Texas Commission on Environmental Quality

Facility Name: Fort Bend Regional Landfill LP

**RE: Permit Application for New Industrial Non-Hazardous Solid Waste Permit for the
Fort Bend Regional Landfill, LP (Proposed Permit No. 96322)
RN102803913 / CN602656373
Response to Technical Notice of Deficiency Tracking No. 29597016**

**Attachment 1 – Comment Response
Summary Table**

**Attachments – Response to T3:
Attachment I.L.2 – Adjacent Landowner
Map**

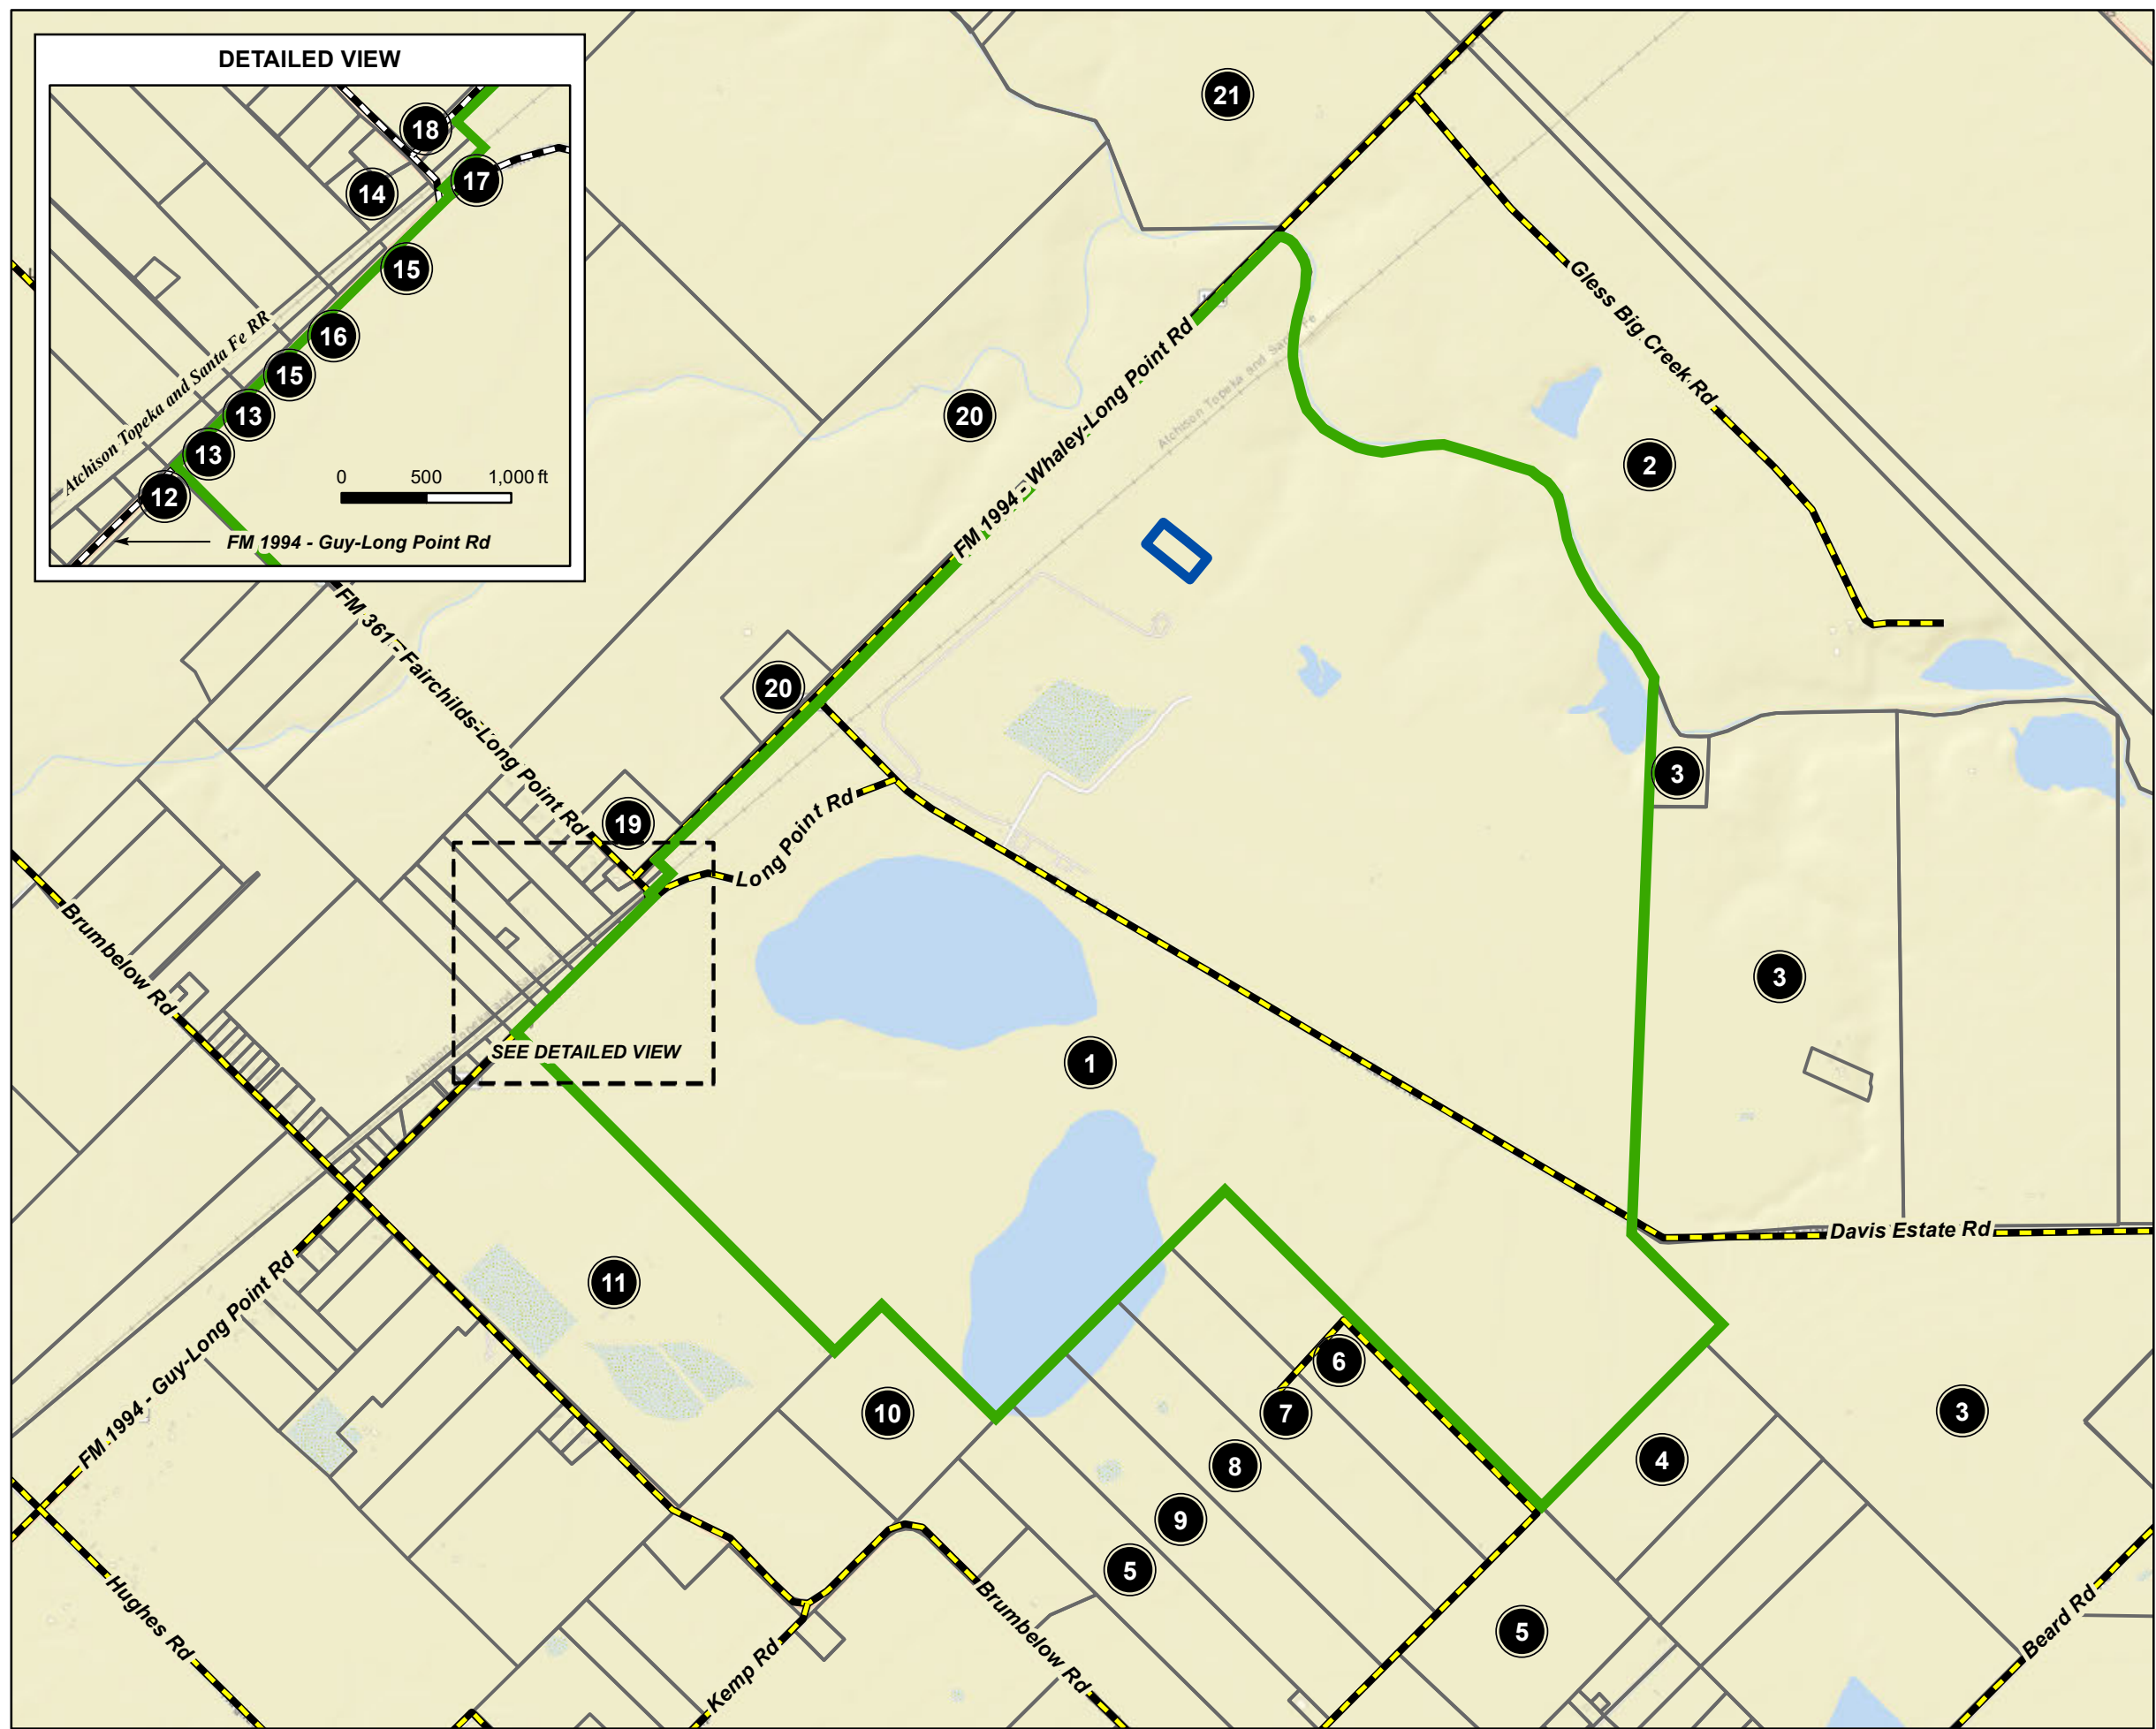
T3	n/a	I	Section I.L	39.5(b)	Incomplete	Revise the adjacent landowner map and list. Attachment I.L.2 Adjacent Landowners Map is missing the identification of one parcel on the northwest boundary between parcels 19 and 20.	According to the Fort Bend Central Appraisal District, the indicated parcel has the same owner as the parcel labeled #20 in the original map. Attachment I.L.2 (Adjacent Landowners Map) has been updated with a label for the indicated property.

ADVANTEK WMS		TEXAS	
<u>PROCESS FLOW DIAGRAM</u>		REV.	
PRE-INJECTION UNIT		C	
NON-HAZARDOUS DISPOSAL WELL			
PUMP & SURFACE EQUIPMENT			
FORT BEND COUNTY		DRAWING NUMBER	
SCALE	ADV003JTAM-ME-30-101		
NONE

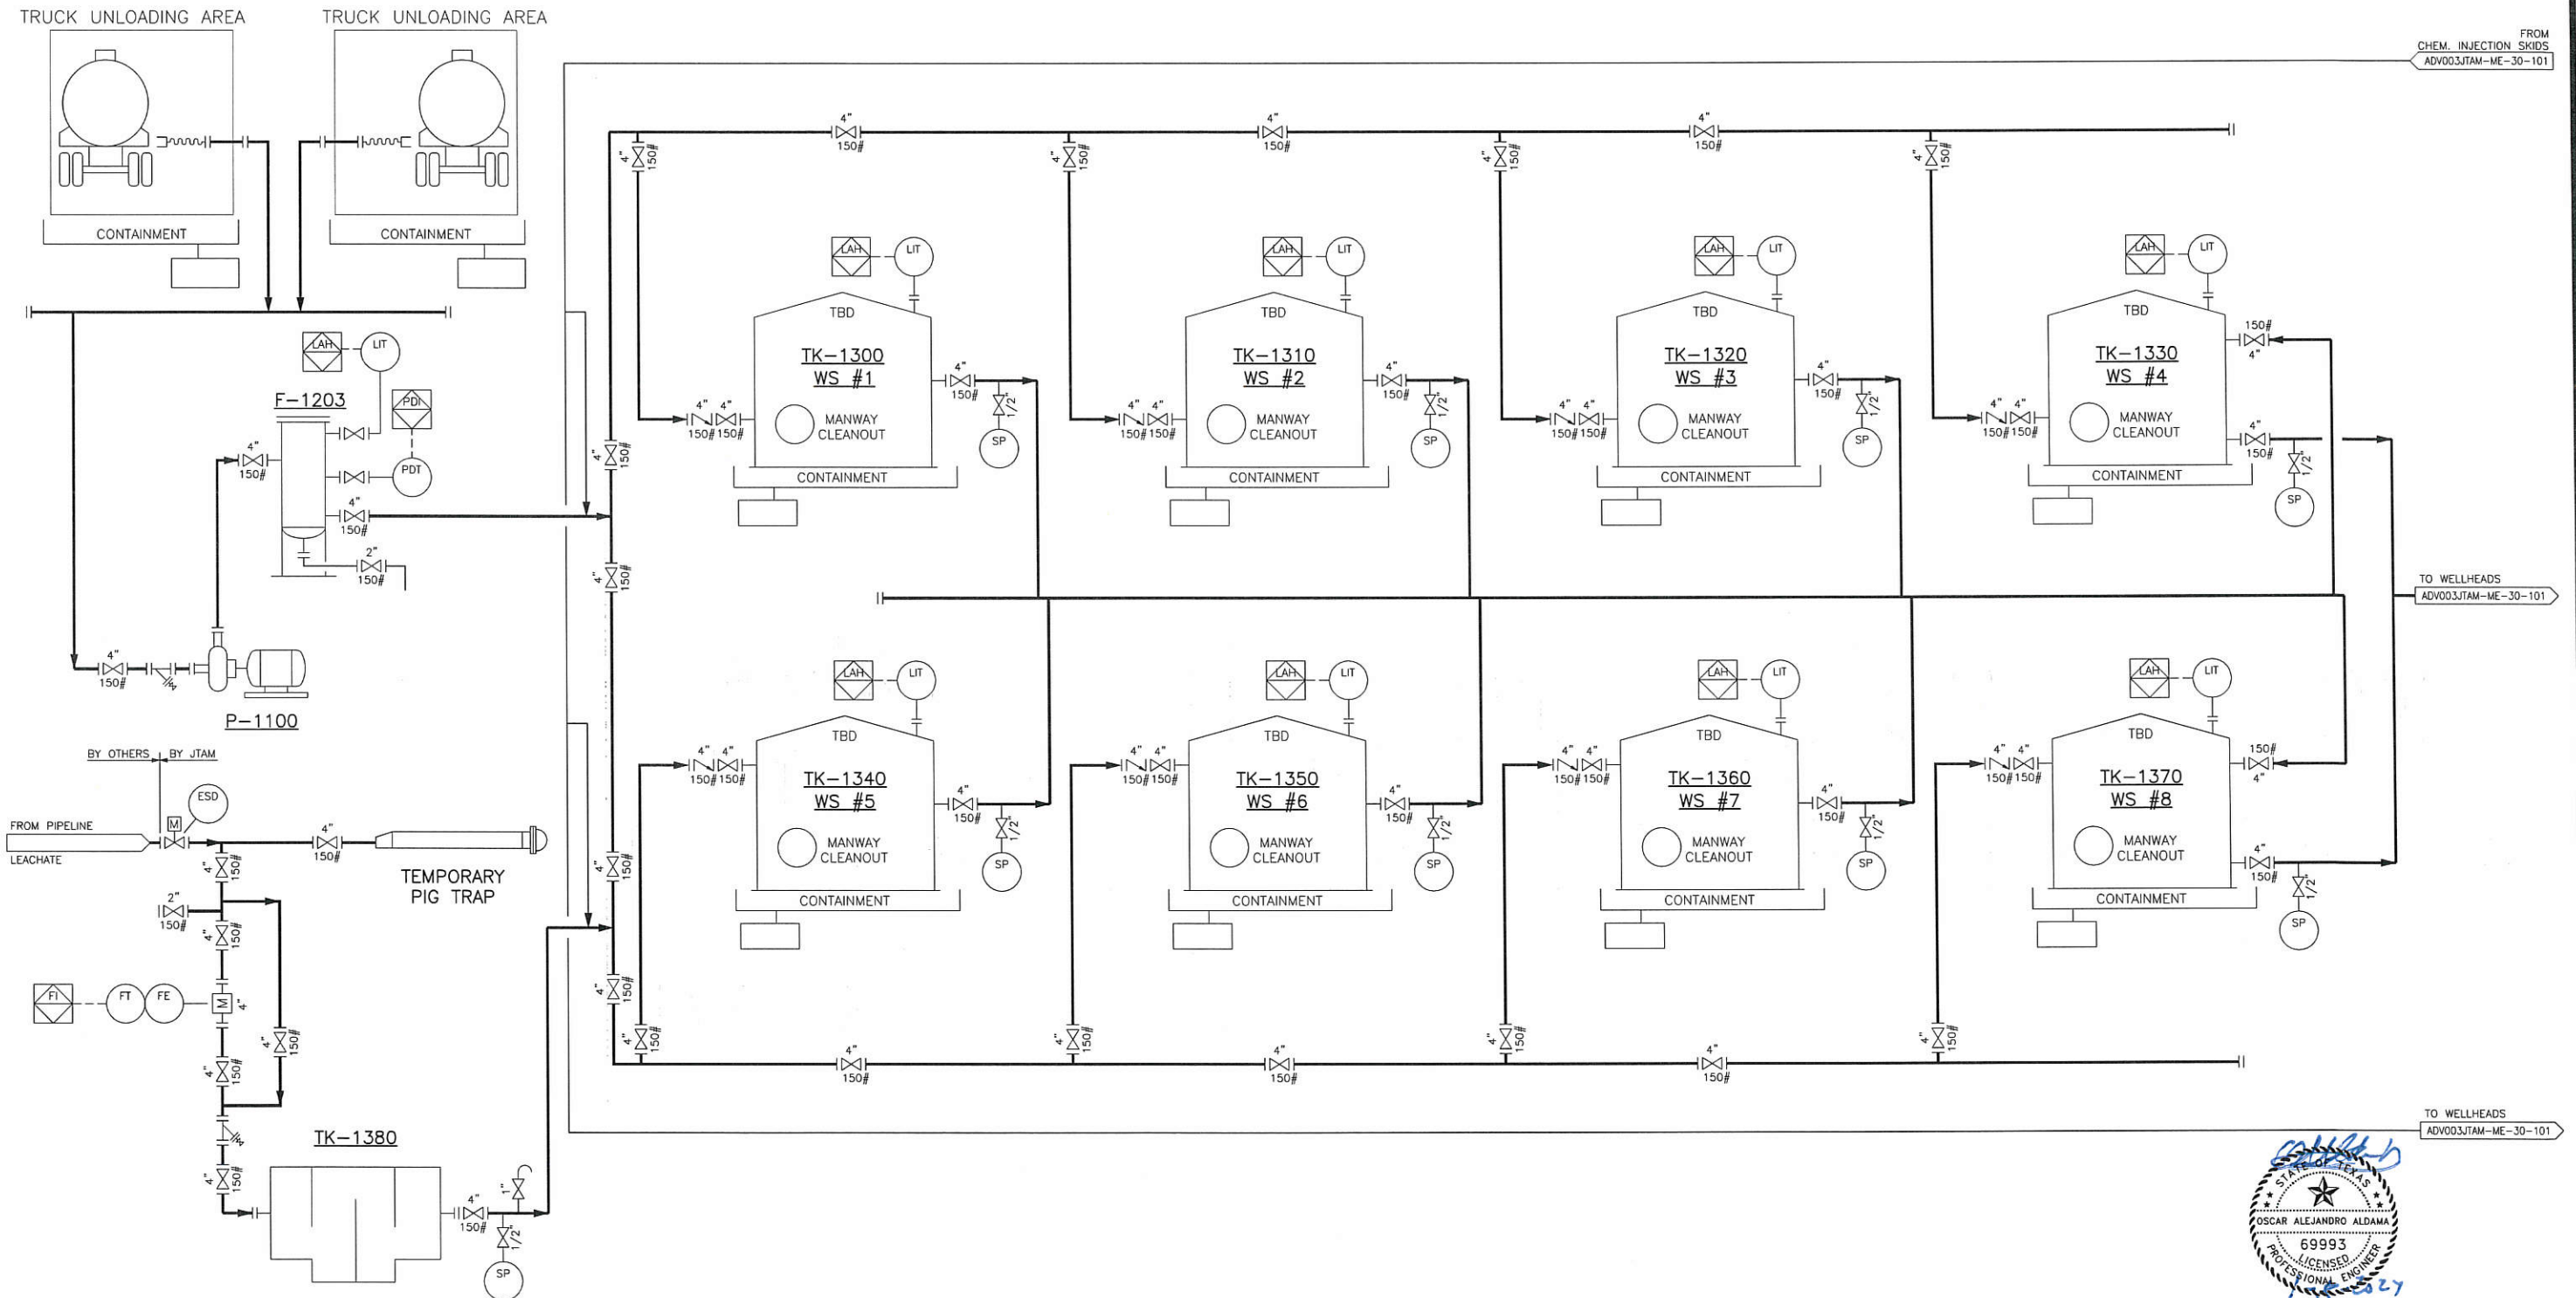
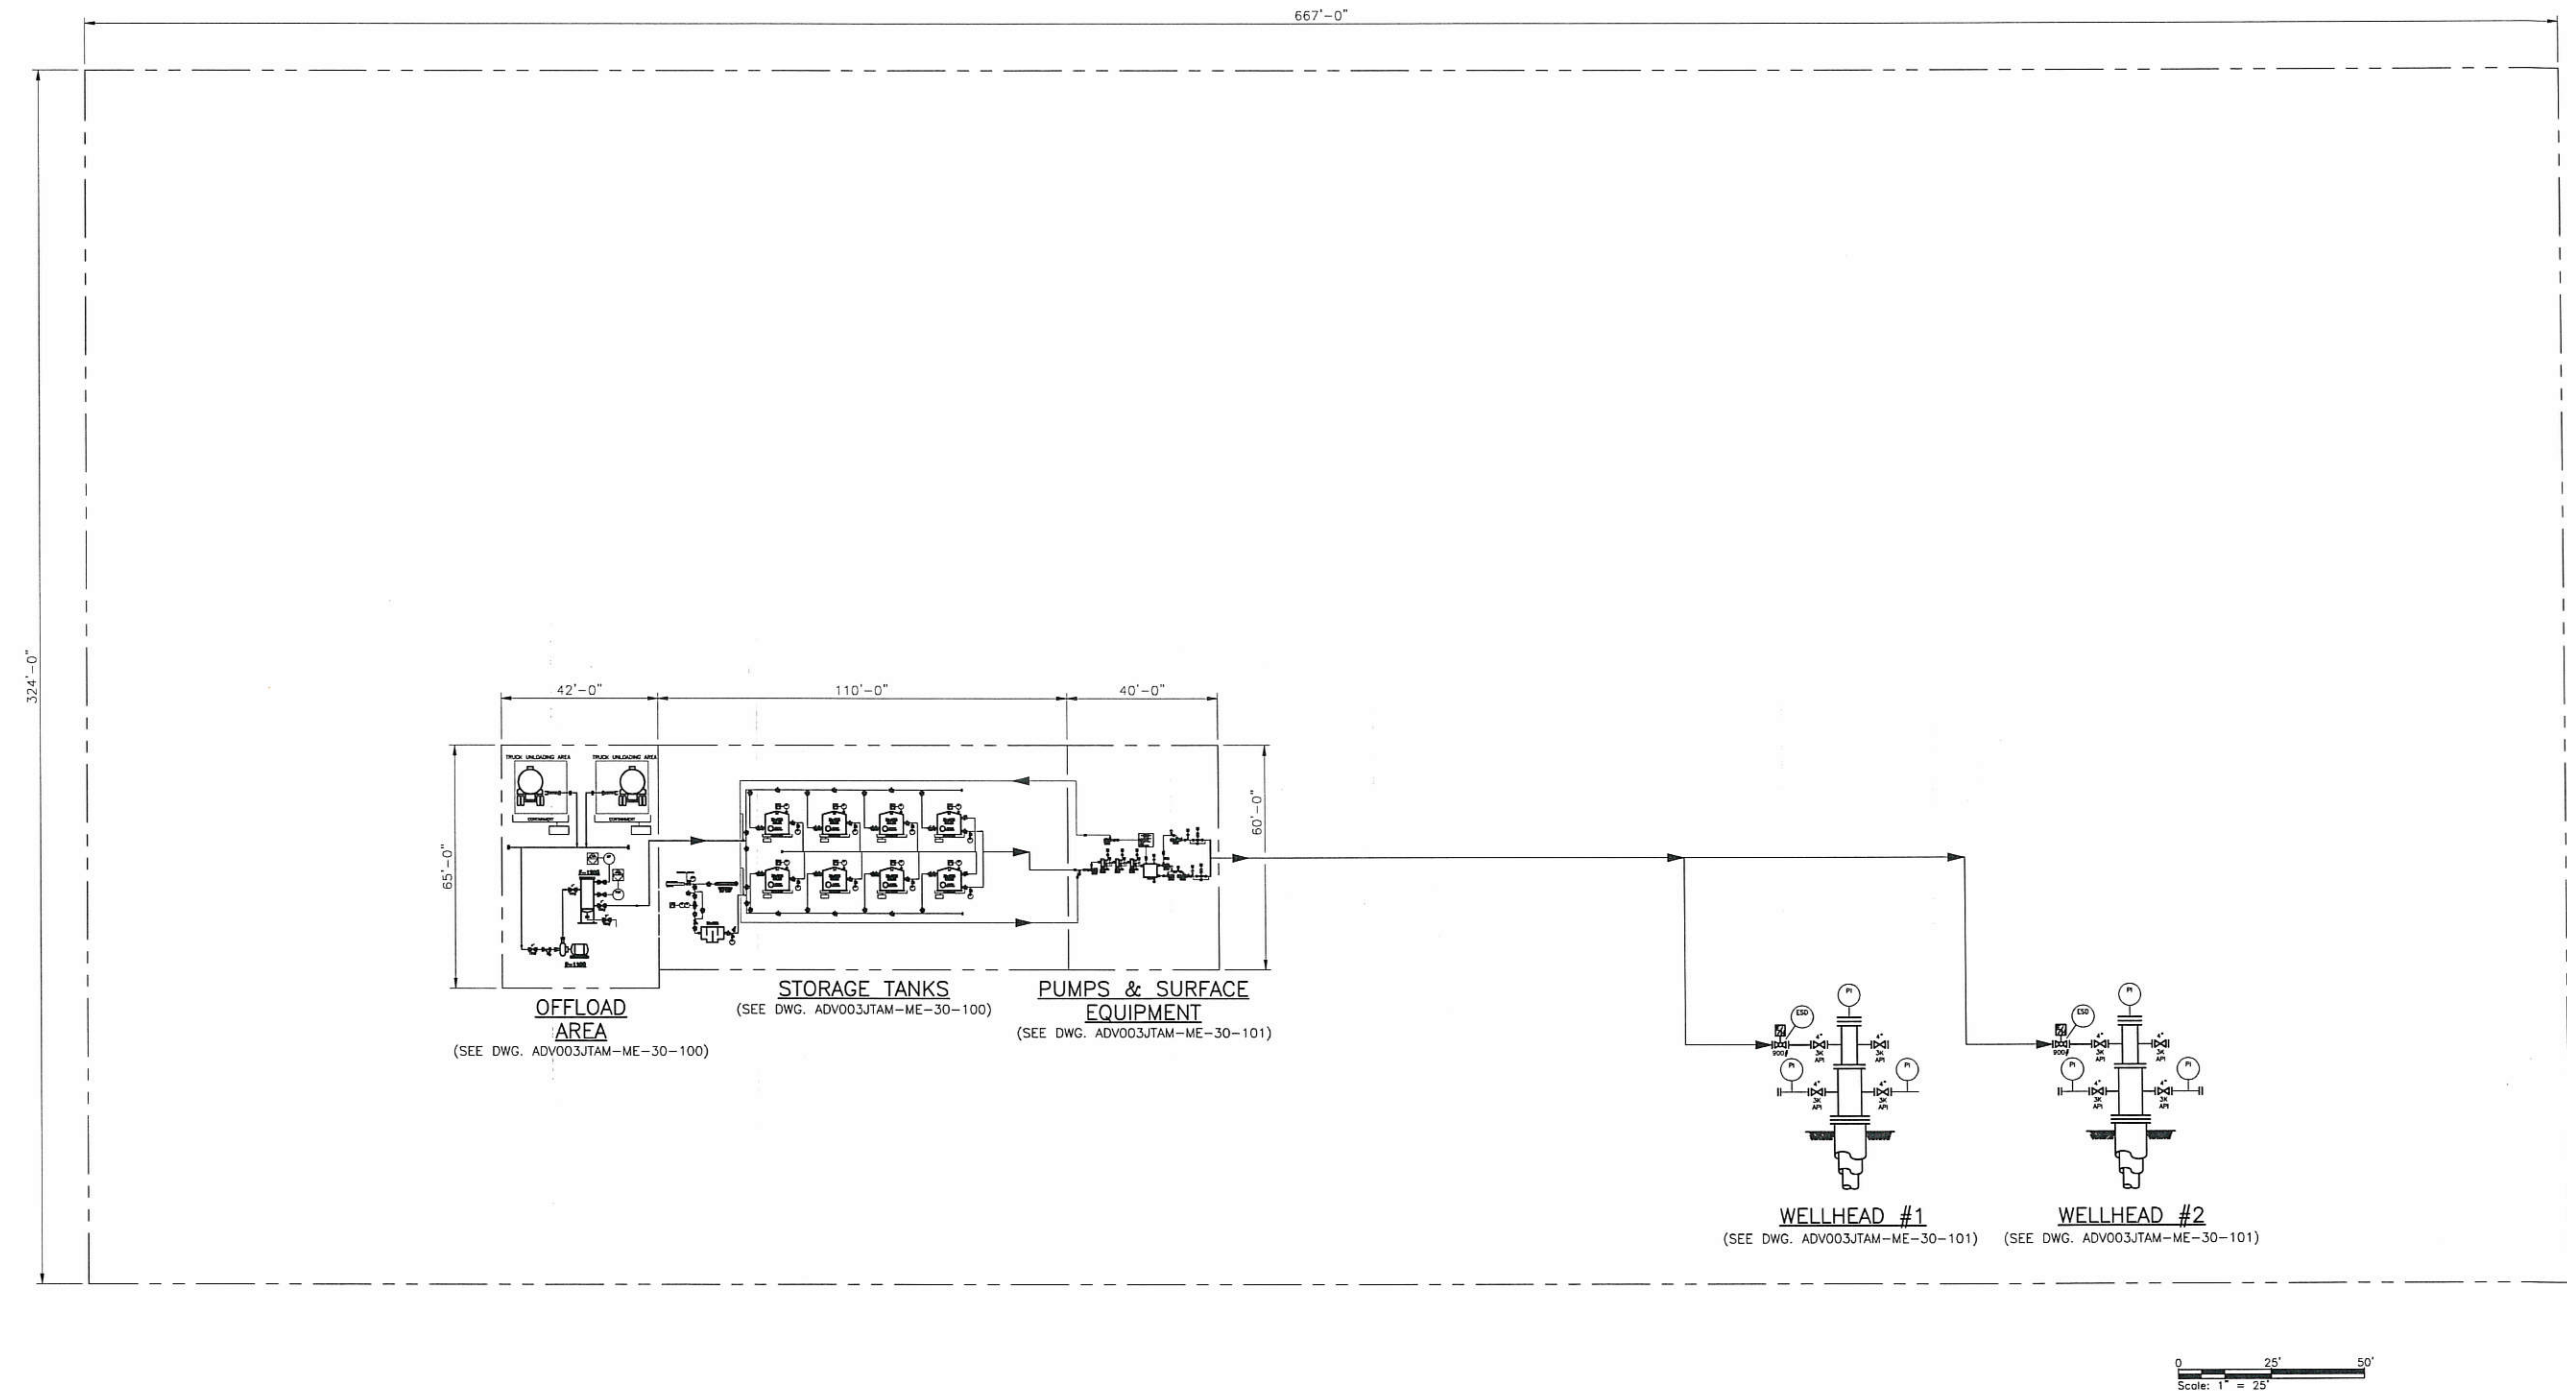
T6	n/a	IV	Attachment IV.B.2	305.45(a)(8)(C)	Incorrect	Correct the dates in the figures named, "Legend and Symbols (2 pages) and "Process Flow Diagram (first page)". These figures have the wrong date of 12/08/24 at the bottom of the page.	The issue dates in Attachment IV.B.2 have been corrected in the attached replacement.
T7	n/a	IV	Attachment IV.D.1	305.45(a)(8)(C)	Incomplete	Show contour intervals on the site map at a scale no less than 1in. = 200 ft and show the location of the leachate line to the UIC Waste Management area.	The replacement Attachment IV.D.1 includes contours at an interval of 2-ft and the location of the leachate line. Note that a smaller scale is used due to the size of the facility, whereas a scale of 1 inch = 200 ft would require breaking up the map into multiple maps.
T8	n/a	VI	Attachment VI.A	305.45(a)(8)(C)	Incomplete	Revise the figure named Leachate Force Main Routing to show the UIC Waste Management area.	The replacement Attachment VI.A includes an annotation showing the area of the UIC Well Pad and Pre-Injection Area.
